**MITCHELL PARK HORTICULTURAL CONSERVATORY  
DOMES  
Peer Review**

**Final Report**

March 14, 2017

**National Trust for Historic Preservation**

Figure 9. Section through hub from original drawings showing hub cladding drainage system

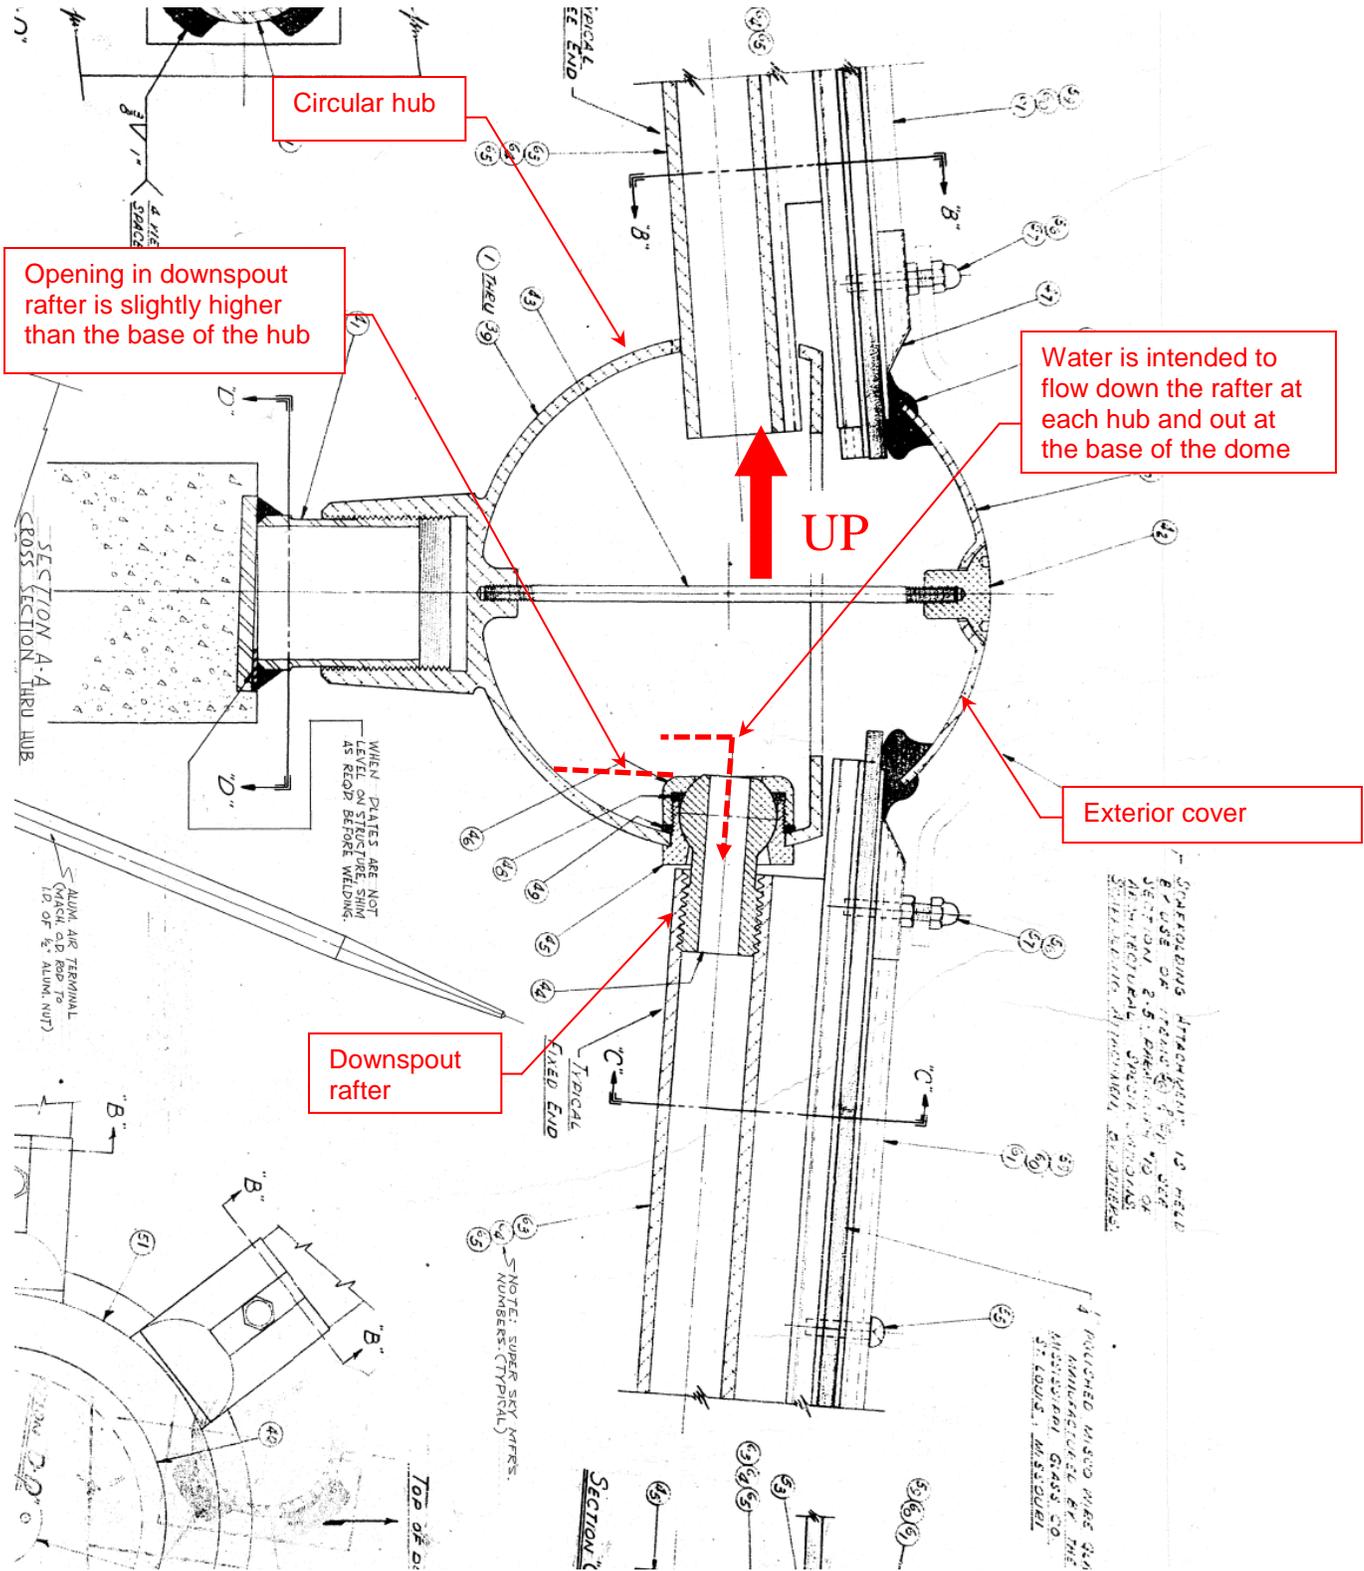
- GRAEF reported that water leakage throughout the domes has historically been a problem and still remains an ongoing issue. GRAEF reported that water was observed sitting in the hub and not allowed to drain. They attribute this problem as due to the fact that the downspout rafter extends higher than the base of the hub (see Figure 9).

Figure 25. Section through glass and aluminum frame showing conceptual pressure cap repair for consideration

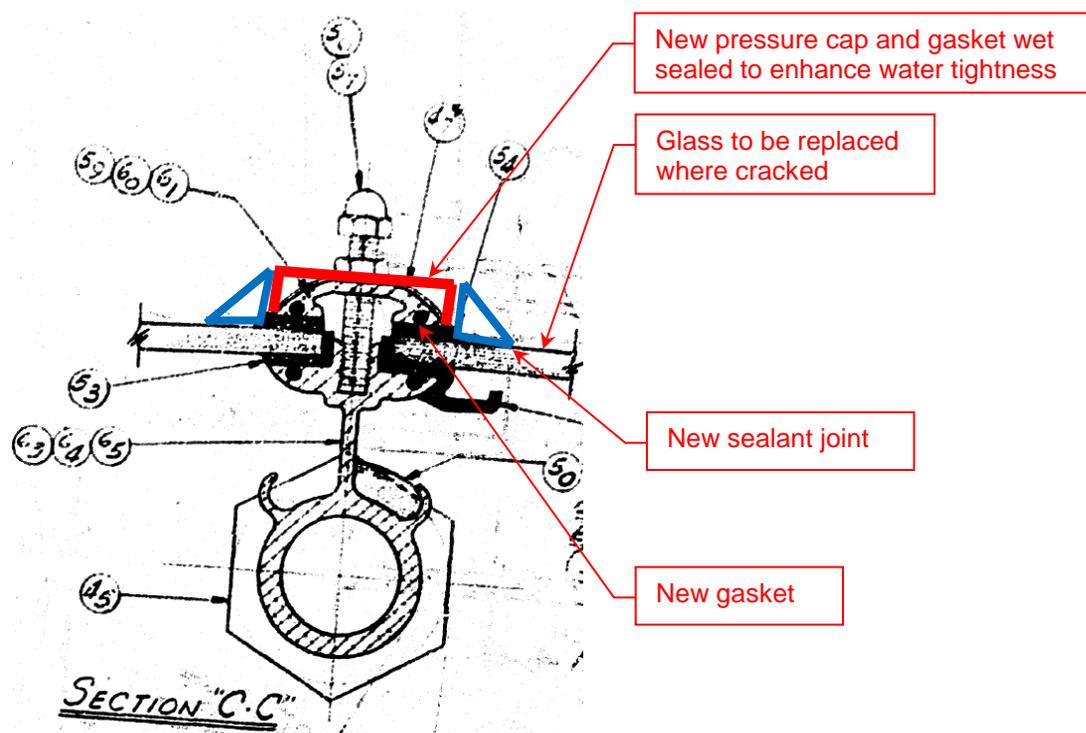
- For weather protection, WJE would normally recommend resealing the glass to aluminum joints around the dome. This is usually performed by a "wet seal" between the glass and the exterior aluminum (the pressure cap). In this case, however, the edges of the existing pressure caps are thin. Obtaining an adequate wet seal joint between the pressure cap and glass would be difficult. As an alternative, removing and replacing the pressure cap with a new redesigned pressure cap would allow for additional weather protection by: a) replacing the exterior glazing seals between the glass and the pressure cap with new glazing seals, and b) a thicker edge detail on the new pressure cap, which would allow a wet seal to supplement the new glazing seal. We believe that this redesign would largely resolve rain water leakage through the dome. We believe that this is a practical step for GRAEF to consider as an addition to their Option 1 repair.

1. Replace existing cracked and broken wired glass in kind, or with laminated glass. Modifications in the glass replacement design could be implemented based on the findings from further investigation and mock-up repairs.
2. Remove and replace all pressure caps and wet seal joints (Figure 25).
3. Clean hubs and install self-leveling sealant at leading hubs (Figure 26).
